TITLE: USE PERMIT NO. 06003, SOUTHLAKE

OFFICE PARK, requested by Eiger Corporation, to develop up to 50,000 square feet of office space, with associated waiver requests, on property generally located at South 91st Street and Andermatt Drive.

LINCOLN CITY/LANCASTER COUNTY PLANNING STAFF REPORT

PROJECT #: Annexation #06004
Change of Zone #06016
Use Permit #06003 - Southlake Office Park

O-3 USE PERMIT EXHIBIT

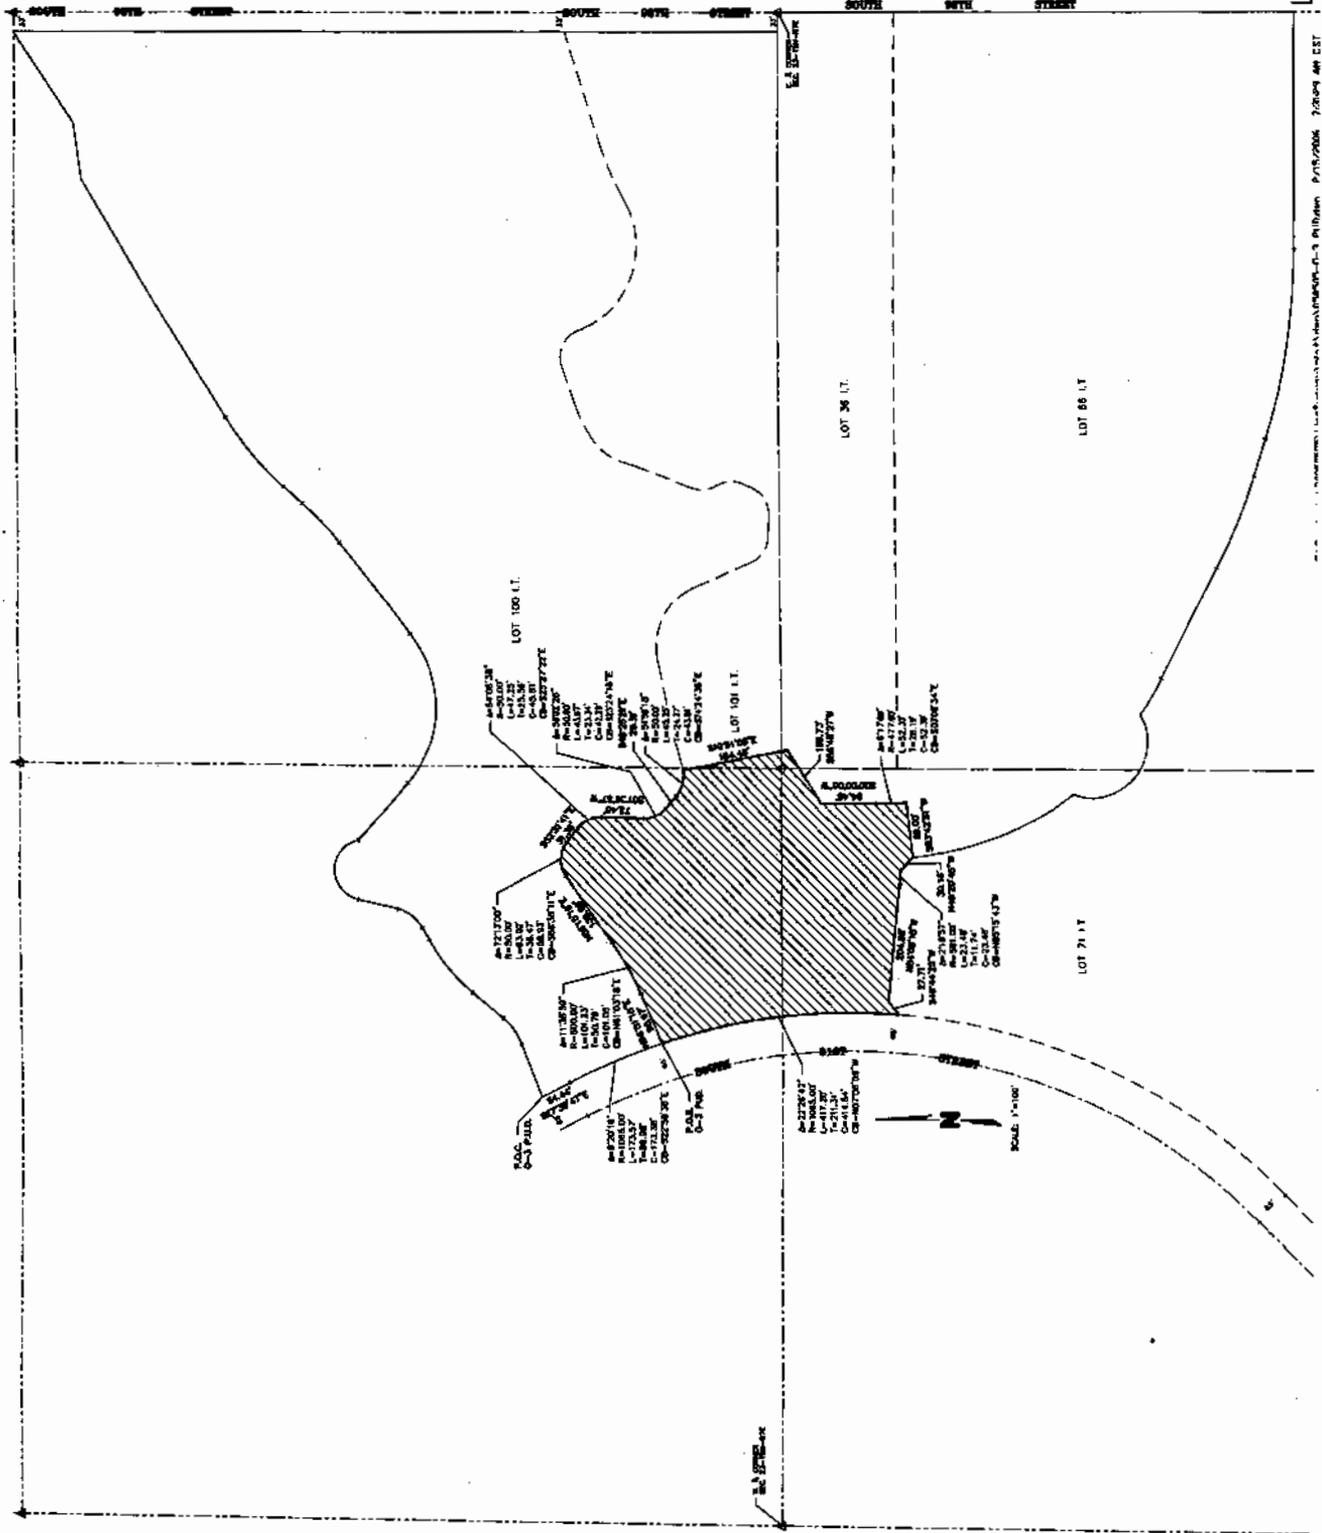
- 2.1.1.2 Show continuous sidewalks in front of all buildings connecting to sidewalks in Andermatt Drive and South 91st Street.
- 2.1.1.3 Show easements per L.E.S. review.

- 2.1.1.4 Provide a summary of trip generation allocation that includes all development subject to AN#01006.
- 2.1.1.5 Delete all references to PUD.
- 2.1.1.6 Show screening per R-T district along the boundary between the O-3 and R-3 districts, and add a general site note that states required screening shall be provided at time of final plats.

- 2.1.1.13 Show Andermatt Drive aligned to the satisfaction of Public Works and Utilities.
- 2.1.1.14 Show the sanitary sewer in a location approved by Public Works and Utilities.
- 2.1.1.15 Show the relocated vehicle entrance ground sign and delete the note indicating "100 Square Foot Southlake Office Park Sign."
- 2.1.1.16 Reduce the size of the buildings to no more than 8,000 square feet of floor area and add a note that states, "No building shall be greater than 8,000 square feet or 28 feet in height." (****Per Planning Commission, at the request of the applicant, 03/29/06****)

2.1.1.16 Reduce the size of the buildings to no more than 8,000 square feet of floor area and add a note that states, "No building shall be greater than 8,000 square feet or 28 feet in height."

P.U.D. GENERAL SITE NOTES

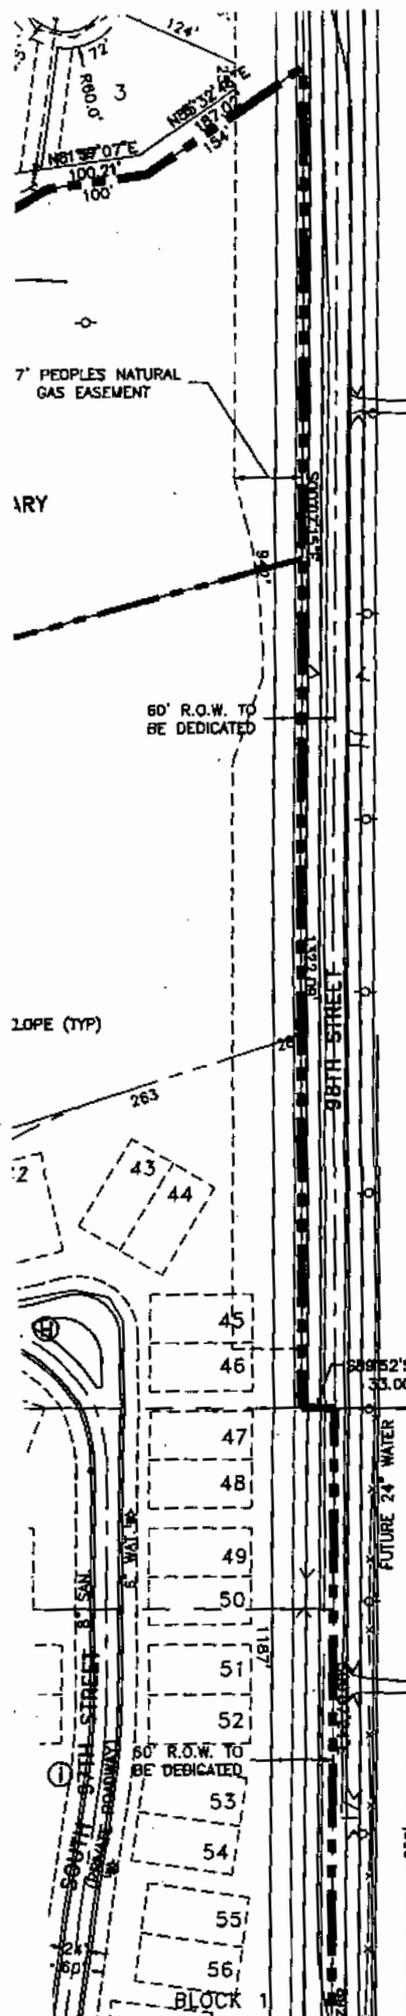
- 2.1.1.1 Delete General Notes #42, 15, 16, 18, 25, 29, and 33. **(**Per Planning Commission, as the request of staff and agreed upon by the applicant: 3/29/06**)**

- 2.1.1.7 Revise General Note #15 to state "LOT DIMENSIONS ARE APPROXIMATE AND MAY VARY AT TIME OF FINAL PLAT."
- 2.1.1.8 Revise General Note #24 to state ".....IN ACCORDANCE WITH LINCOLN MUNICIPAL CODE TITLE 27."

- 2.1.1.9 Revise General Note #26 by deleting "AS AMENDED BY THE SOUTHLAKE REGULATORY MODIFICATIONS."
- 2.1.1.10 Revise General Note #28 to read as ".....STREET TREES AND REQUIRED LANDSCAPE SCREENS TO BE REVIEWED....."

- 2.1.1.11 Separate General Notes #15, 30, 35, 37, 38, 39, 43, and 47 into a separate table labeled 'Waivers'.
- 2.1.1.12 Provide enhanced screening along the O-3/R-3 boundary consistent with the screening requirement for the R-T district.
